HEARING DATE: July 13, 2021

SUBJECT: FP-2021-0038
Apex Northwest No. 2 – FP

B. Final Plat (dated: 5/17/21)

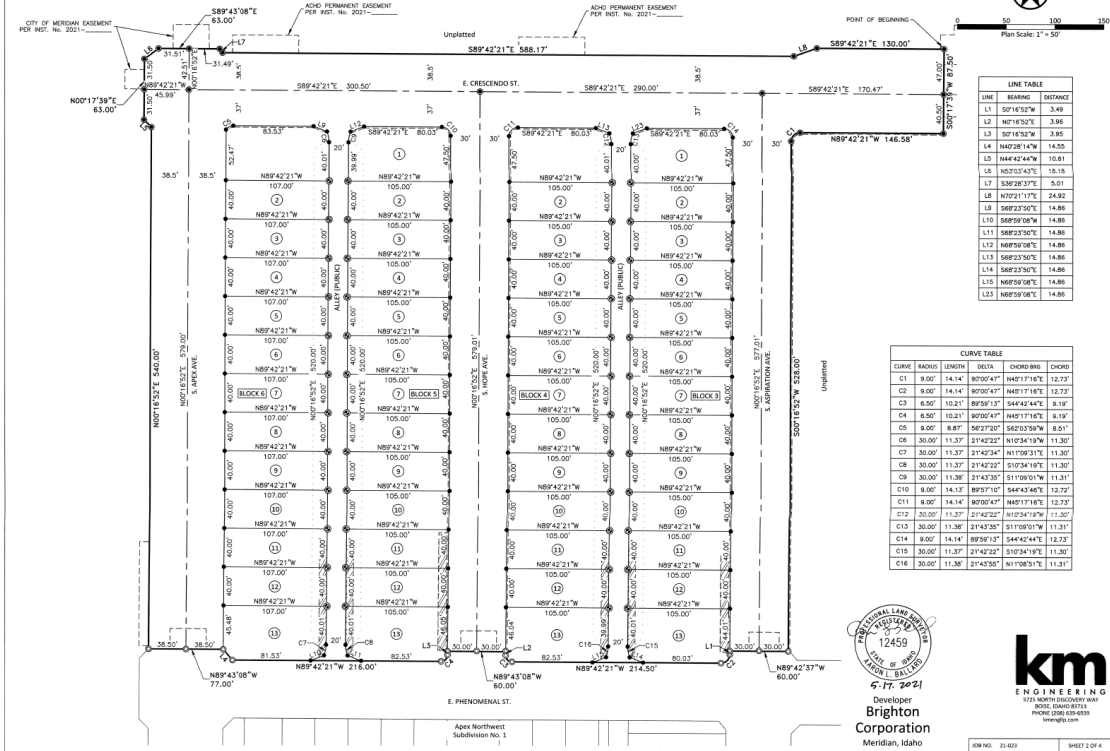
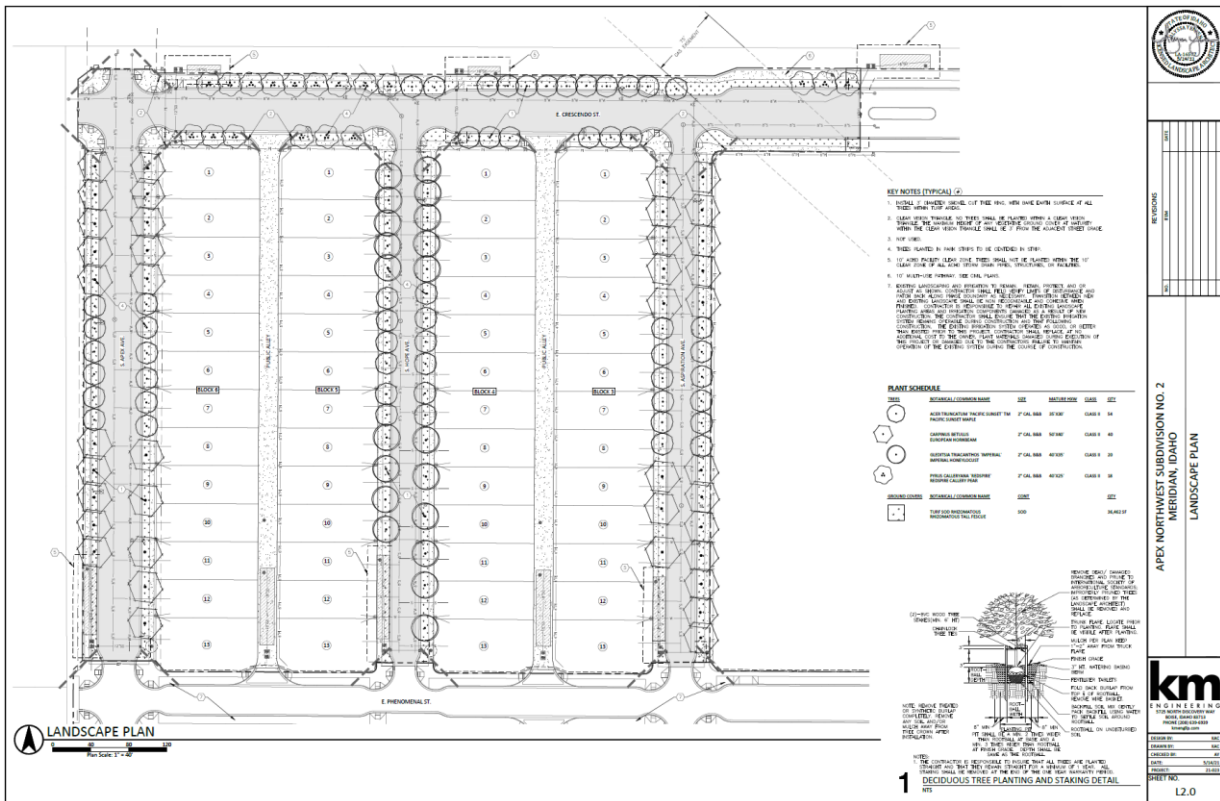
- a. Depict the Lot numbers for Lot 1, Block 6 and Lot 1, Block 4 that are missing on Sheets 1 and 2.
 - b. References – R4: Include the recorded book & page number of the Apex Northwest Sub. 1 plat on Sheet 1.

- c. Include the CP&F recorded instrument number of the East ¼ corner section on Sheet 1.
 - d. Include the recorded instrument number of the ACHD permanent easement graphically depicts and noted on Sheet 2.

- e. Include the recorded instrument number of the City of Meridian easement graphically depicted and noted on Sheet 2.
 - f. Note #8: Include the recorded instrument number of the ACHD Landscape license agreement.

- g. Note #9: Include the recorded instrument number of the ACHD public right-of-way easement (sidewalk).
 - h. Note #10: Include S. Apex Ave. in the note in accord with preliminary plat condition #2a.

- i. Note #14: Include the recorded instrument number of the CC&R's.
 - j. Certificate of Owners: Include the recorded book & page number of the Apex Northwest Sub. 1 plat.

- k. Street buffers are required to be placed in common lots maintained by the Homeowner's Association where they extend beyond the right-of-way as set forth in UDC 11-3B-7C. *Alternative compliance may be requested to this standard as set forth in UDC Table 11-5B-5.*

- A copy of the revised plat shall be submitted with the final plat for City Engineer signature.*
5. The landscape plan prepared by KM Engineering, dated 5/14/2021, included in Section V.C, shall be revised as follows:
